DEVELOPMENT ASSESSMENT UNIT
Minutes of the Development Assessment Unit
Shire of Augusta Margaret River
On 30 July 2019

DEVELOPMENT APPLICATION ASSESSMENT (DAU)
Report to Manager Planning and Development Services
Proposed Building Envelope Variation, Dwelling and Development Outside the Building Envelope (Chalet, Water Tank and Outbuilding) at 52 (Lot 19) Ashton Street, Margaret River

P219006; PTY/8999

Figure 1: Proposal Plan

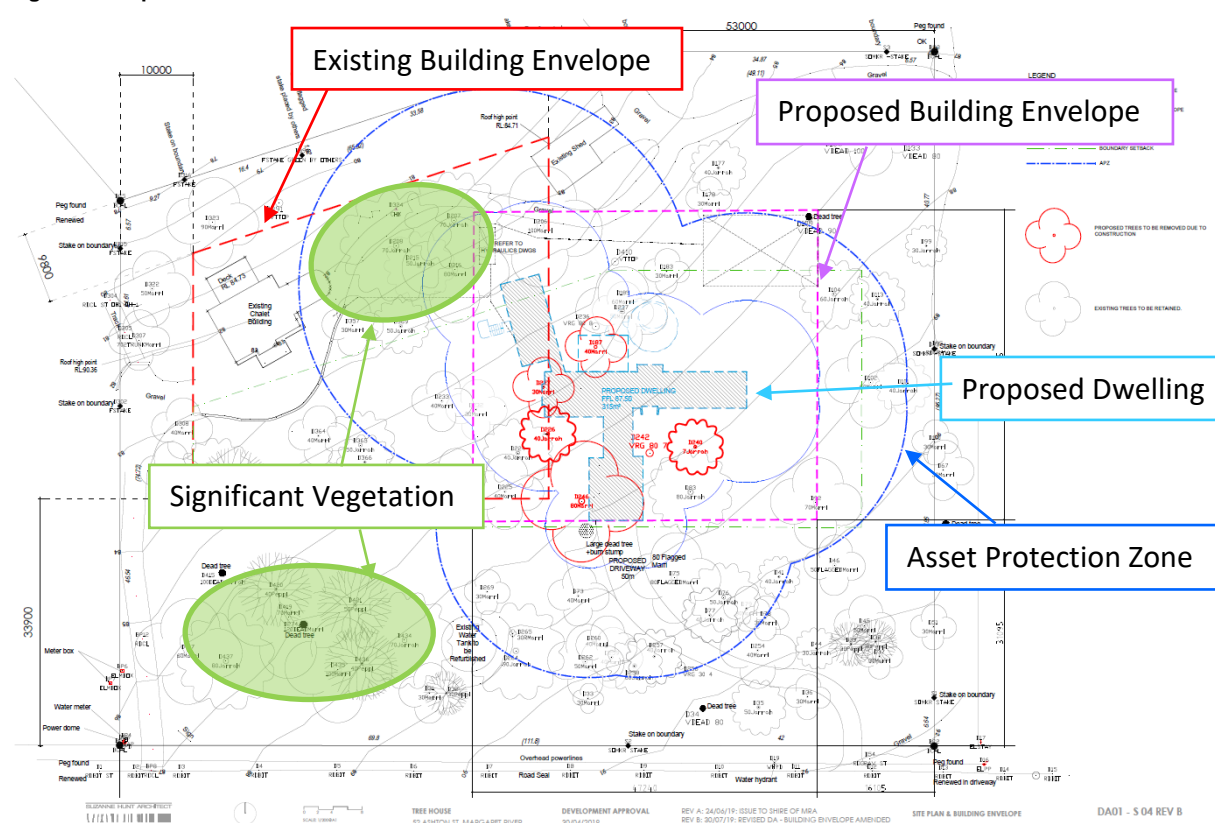
The amended location of the envelope on site is preferable to the location of the existing envelope for the opportunity it provides to retain the significant stands of trees. The dwelling has also been sensitively located in the area of least quality vegetation. The relocation of the envelope however raises questions about the location of the existing chalet and shed on site.

It was agreed with the proponent that the Shire considers the existing chalet and shed as development outside the proposed envelope. While this is an unusual situation, the outcome would be a reduction in impacts to significant vegetation as described above by limiting all future development to the site of the proposed envelope. Discretion under LPS1 clause 5.5 is required in this regard.

It is also noted that there is an existing gravel track in the north east of the lot straddling the property boundary and providing access with the adjoining northern lot. This is a legacy situation not secured by a legal mechanism and is recommended to be addressed as a separate matter to the subject application.

The proposed envelope complies with the setback standards under Schedule 9 of LPS1 with the exception of the setback to the northern boundary. A rear setback guideline of 30m is provided under LPS1 and the envelope would be setback 16.5m to the boundary. The setback variation has been assessed and is considered acceptable, pursuant to LPS1 clause 5.5 and clause 5.10.2, for the following reasons:

- The existing building envelope is already setback 10m to the northern boundary and therefore the proposed envelope would increase this setback distance.

- Adequate screening between the proposed envelope and adjoining lots is provided by existing vegetation.
- The proposed building envelope is generally consistent with other building envelopes within the area.
